TECHNICAL MEMORANDUM

Project No. 20446521-003-TM-Rev0-6000

DOMES DESIGN ISSUED FOR CONSTRUCTION DRAWINGS

PROJECT
WASTE ROCK DOME DESIGN
LUPIN MINE CLOSURE
NUNAVUT, CANADA

TITLE
PROPOSED WASTE ROCK DOME

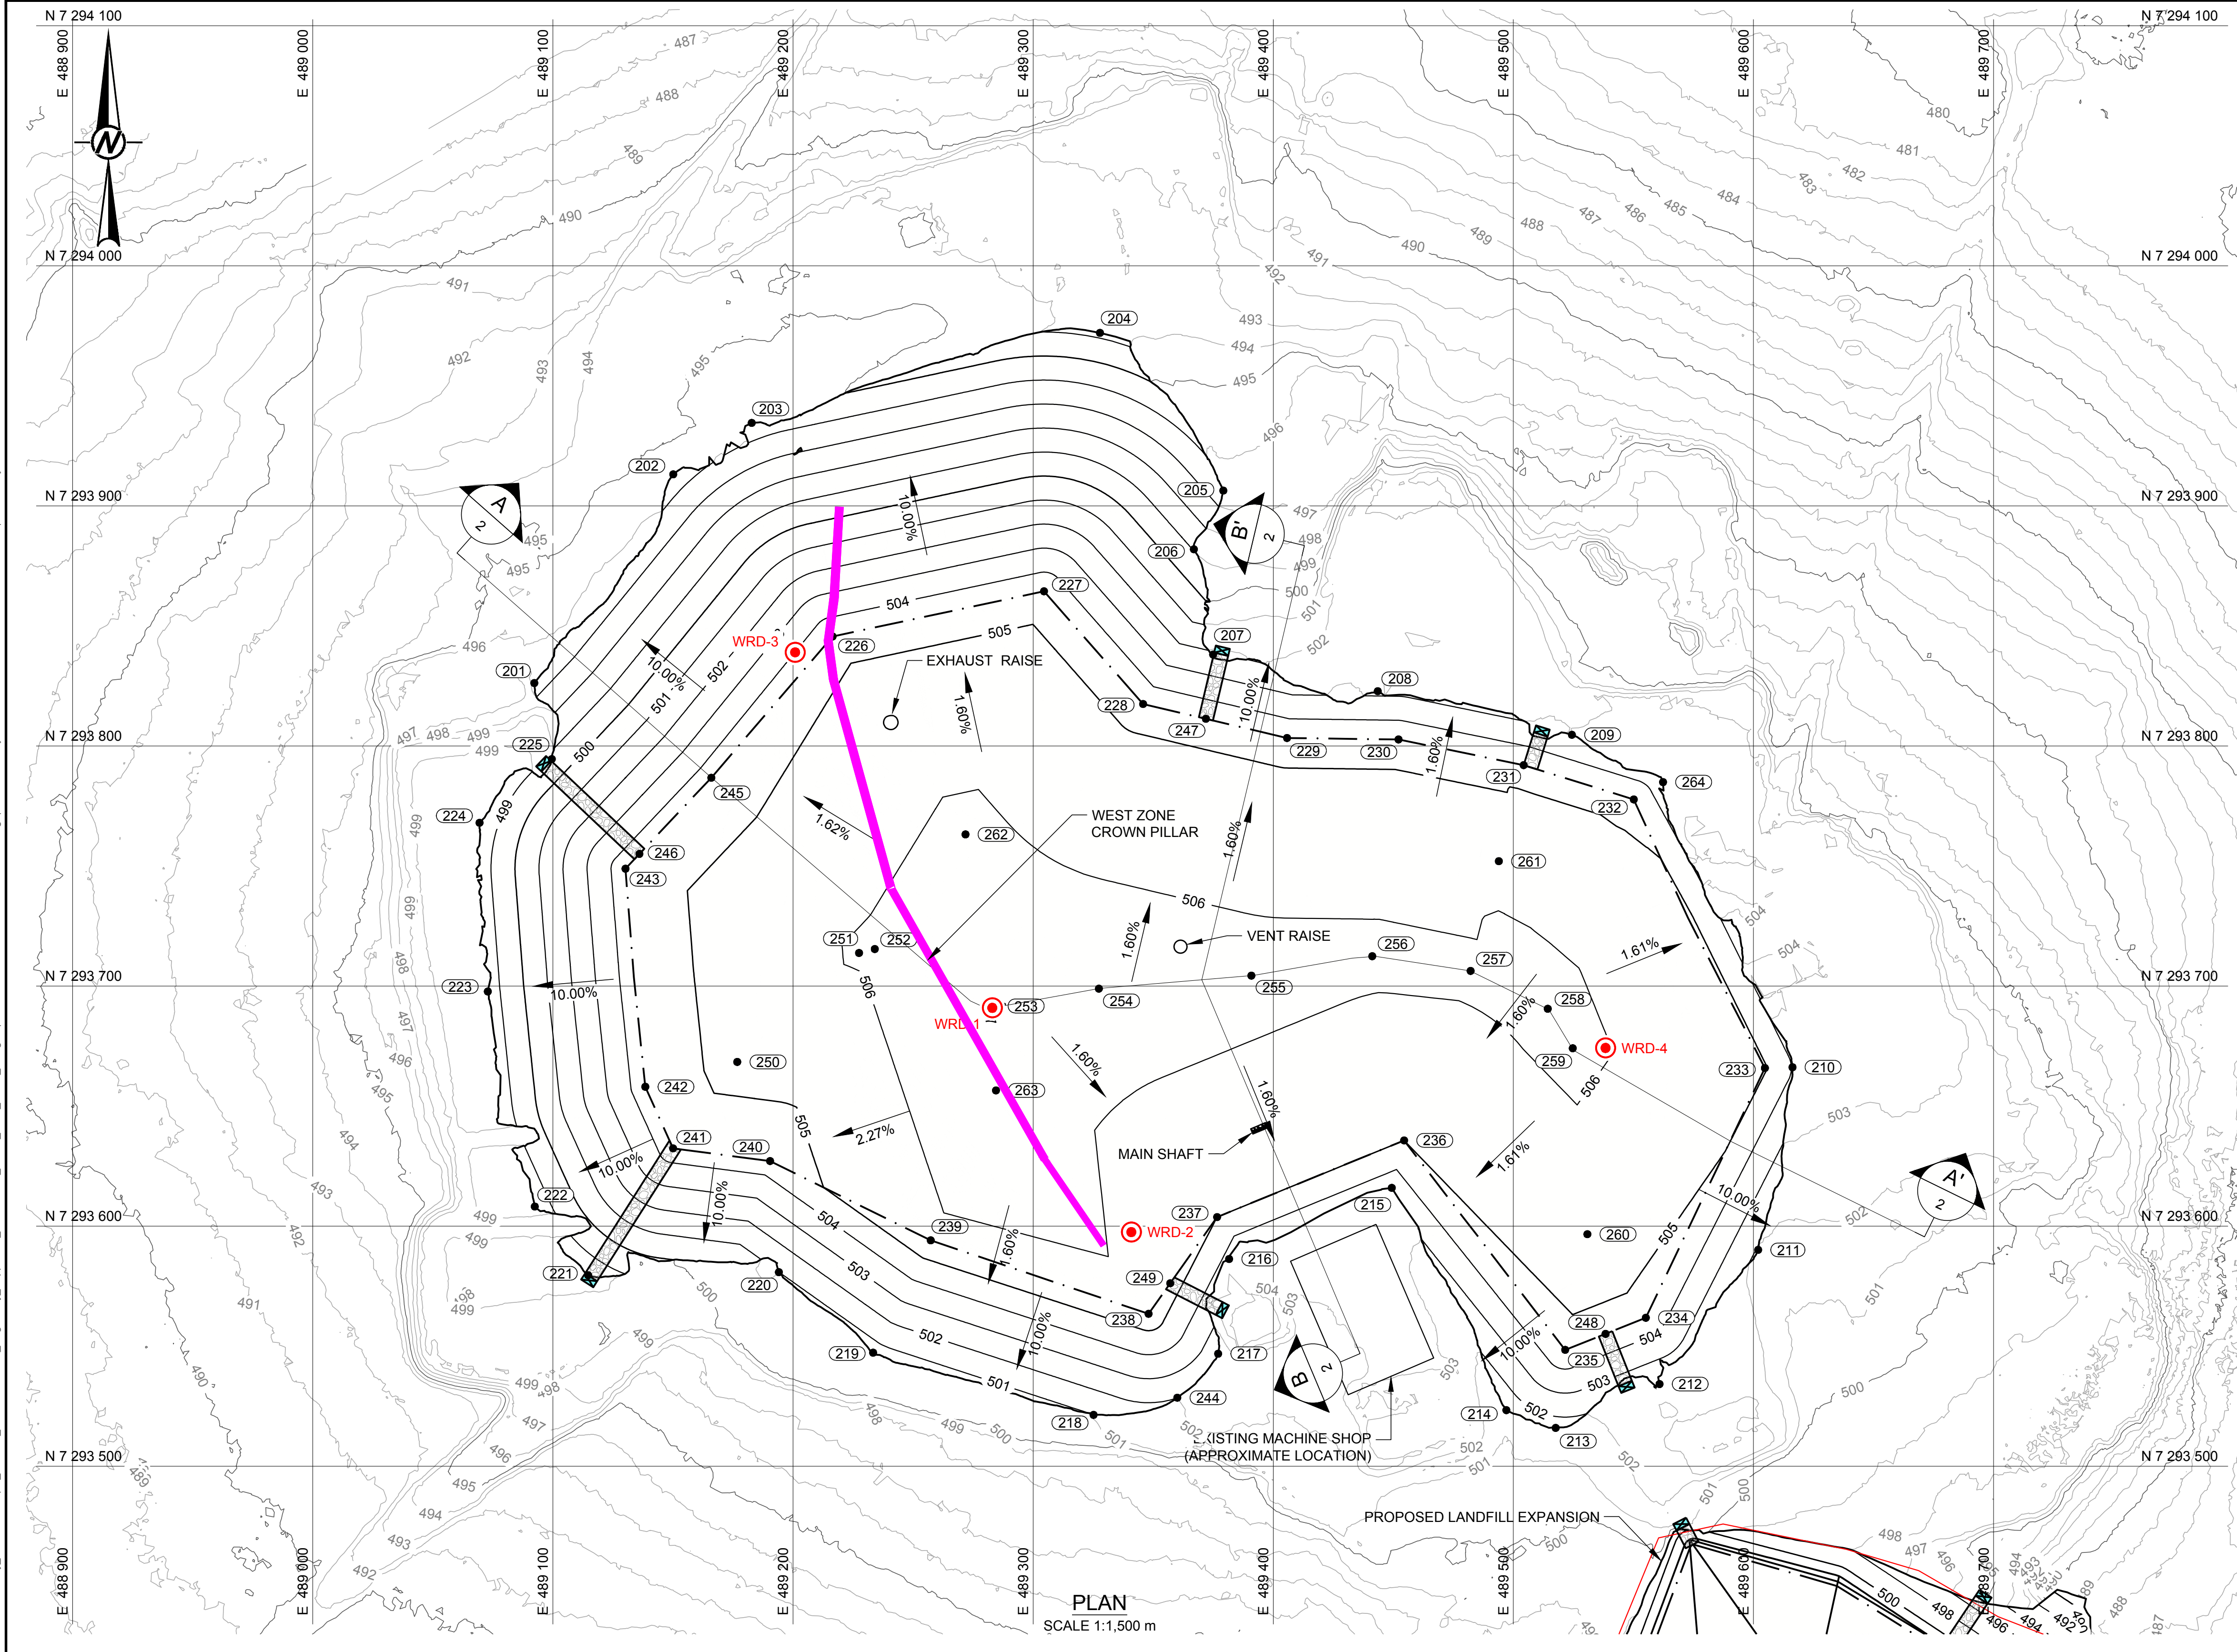
- a. lack of detailed grading information for top of "dome";

- c. no protection against rill erosion on long 10% slope surfaces;

h. failure to show locations of shaft, crown pillar area, that will be buried under the dome.

Our review of the plans and sections observed that the 10% slopes, about 300m of top edge in the north portion of the “dome” is as much as 10m high and this extends out about 100m to the toe. The west and southwest side of the dome has a height of between 5m and 6m and thus extends out some 50+/- meters in these areas. Other than indicating that a berm will be constructed on the top edge of the dome to direct “dome surface” runoff to drainage chutes, no erosion control measures are included for ensure erosion protection and stability of these long 10% esker slopes. The plans and sections indicate that surface water runoff from the 1.6% surface slope, is expected to be drained off the dome, down the 10% slopes, via 6 runoff “drainage chutes”. Surface runoff is to be directed to these “chutes” by a small perimeter berm along the edge of the dome surface (0.5m high, 0.5m crest width, 2:1 slopes) constructed with the same esker material as the 1m dome cover surface. Given the importance of this berm in preventing overland sheet flow to the 10% slopes, we question the long term stability of the berm design as presented.

No information is provided to support the designs of the top perimeter berm, the chutes, or the stilling basins. No drainage elevations are provided with respect to surface grading on the top of the dome edges, and no information is provided with respect to the drainage runoff flows leaving the “stilling basins” at the toe of the dome. No details are provided for the toe of the 10% slopes, nor for runoff from “stilling basins”, which in some locations could undercut the toe of the cover (see north central discharge). In the absence of this information, we do not have confidence that the design as shown will be stable in the long term. The proposed designs as shown reinforce our concerns that the 10% slopes will at a minimum be subject to long term rill erosion even if the upper berm controls runoff to the discharge chutes. We are concerned about the long term performance integrity of the up diversion berm if constructed as shown with esker material. We note that any failure along of the top berm would result in additional erosive forces on the 10% slopes. We are concerned that no toe stabilization / armouring measures are included to protect the toe of the 10% slope. Provide information listed in this paragraph to demonstrate how the long-term erosion stability of the designs is being ensured.

Grading details for the top of the dome are provided on Dwg. 19136158-0002-CM-0001_Rev 1. The surface has been modelled in ACAD and layout points were provided for construction. As indicated in Note 7, the final elevation of the top surface will be varied to suit the actual volume of waste rock that is imported from elsewhere on the mill site; however, the design slopes of the surfaces will not be changed.

A berm and swale system will be constructed at the perimeter of the top surface to direct runoff into the six chute structures. This will prevent any runoff from the top surface from “spilling over” and running down over the 10% sideslopes. As a result, runoff from the 10% sideslopes will be limited to that generated from rainfall or meltwater from the slopes themselves. It is noted that the esker material is a well graded material that typically contains about 39% gravel. Should incipient rilling erosion occur on the sideslopes, the esker material will tend to exhibit “self-armouring”.

The locations of the crown pillar area and shafts has been added to Dwg. 19136158-0002-CM-0001_Rev 1 for information.

The perimeter berm alignment has been designed to provide a gentle positive gradient towards the entrances to each of the chutes. This will prevent a buildup of deep water against the inside of the perimeter berm. Given the gentle gradient, the flow velocities along the swale towards the entrances to the chutes will be low, and as discussed above the esker material is expected to self-armour. In any case the presence of erosion protection at the entrance to the chutes will prevent erosion from cutting down below the grade of the sills at the top of the chutes.

As discussed above, the discharge from each stilling basin will generally flow radially away from the dome, mirroring the natural drainage pattern. Note 11 on Dwg. 19136158-0002-CM-0001_Rev 1 directs the Contractor to “construct berms or ditches as necessary to direct flow from drainage chutes away from the toe of dome fill.” Such berms or ditches will be field fit to the actual ground surface that remains after the waste rock is removed from the areas surrounding the dome.
